DECLARATION FOR THE RECORD OF DECISION

Port Washington Landfill

Port Washington Landfill #130025
Port Washington, Nassau County, New York

Landfill Capping Detail

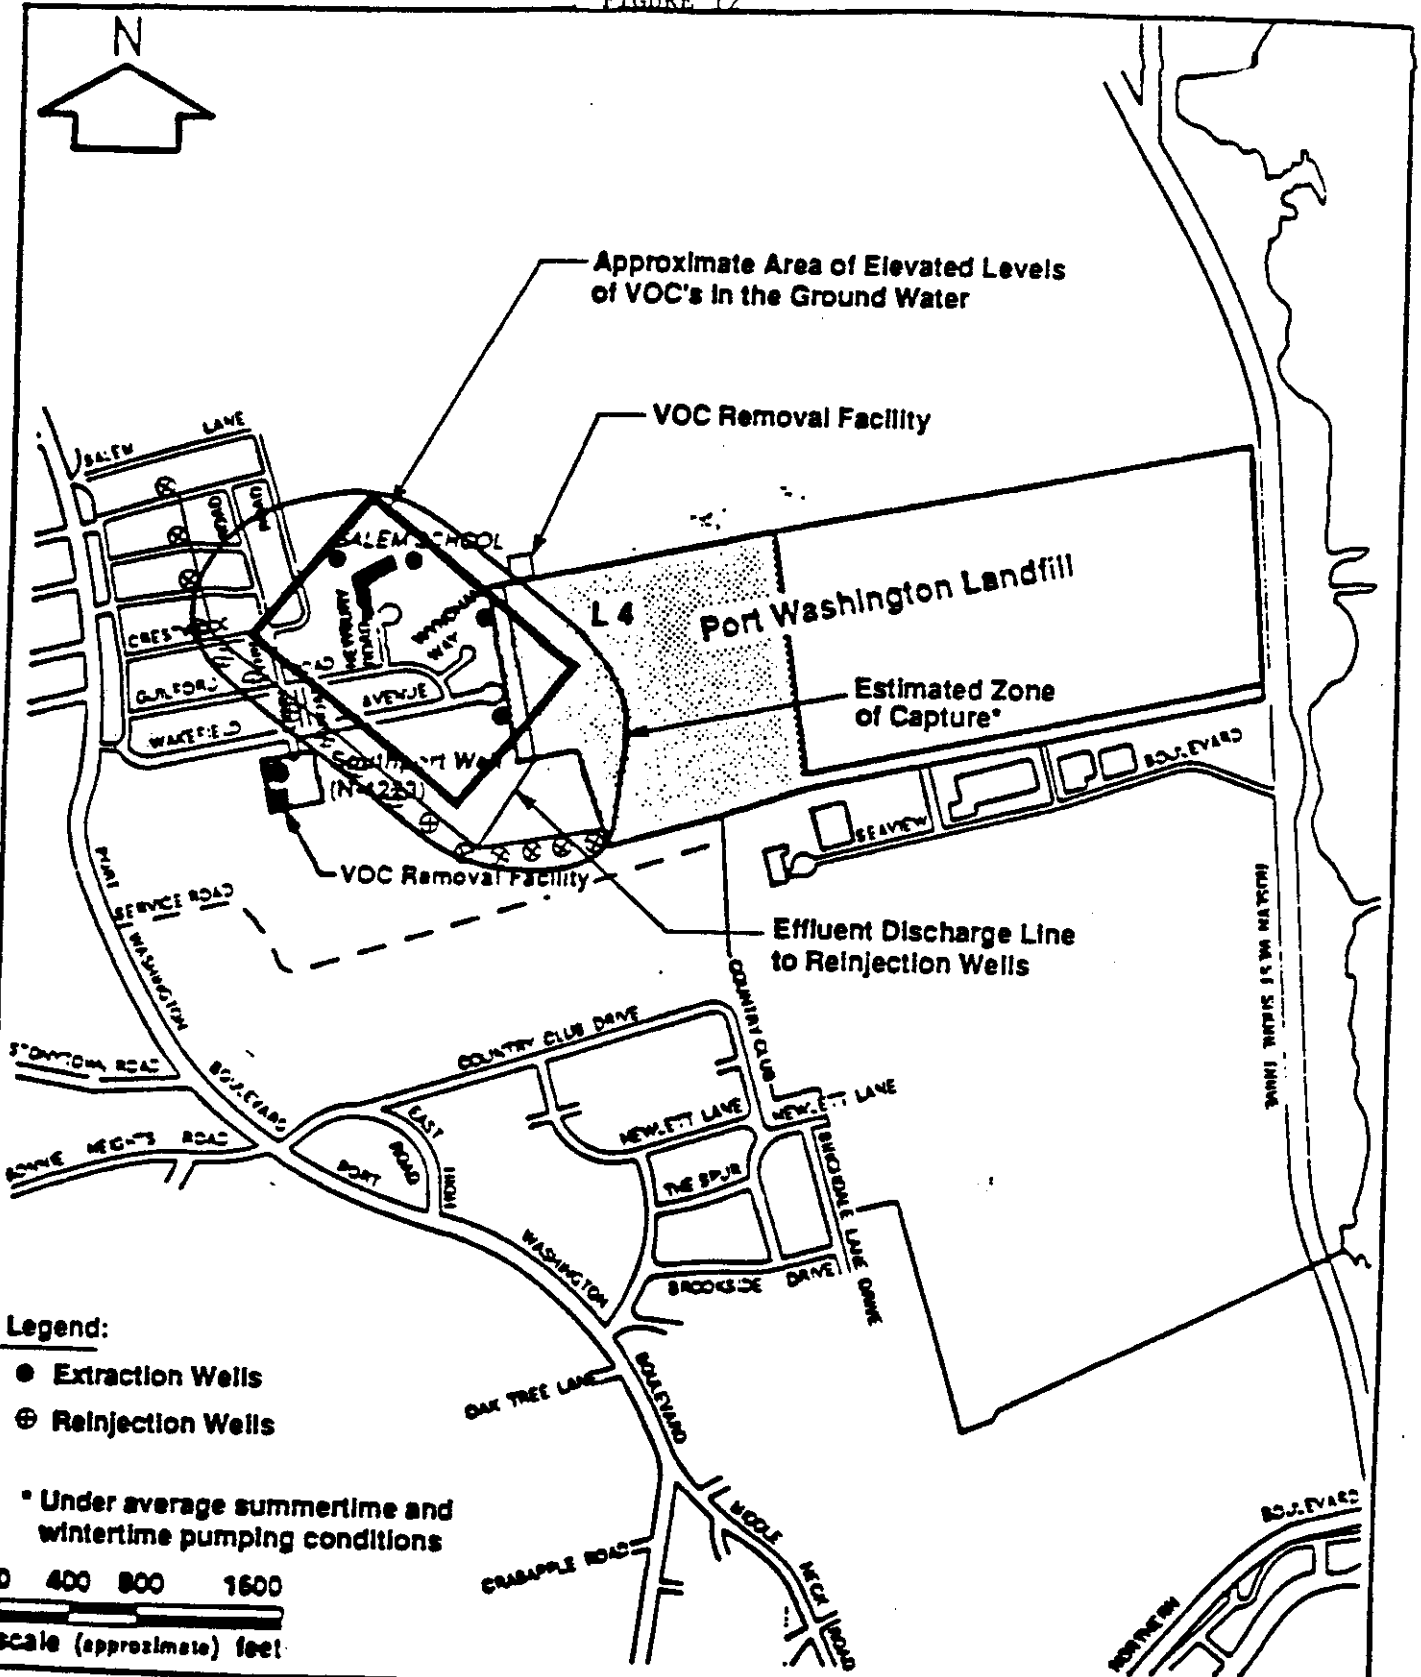
The design of the cap itself will include several layers of material (figure 11). First, a 12 inch gas venting layer of sand will be placed on L-4. Within this layer a perforated piping
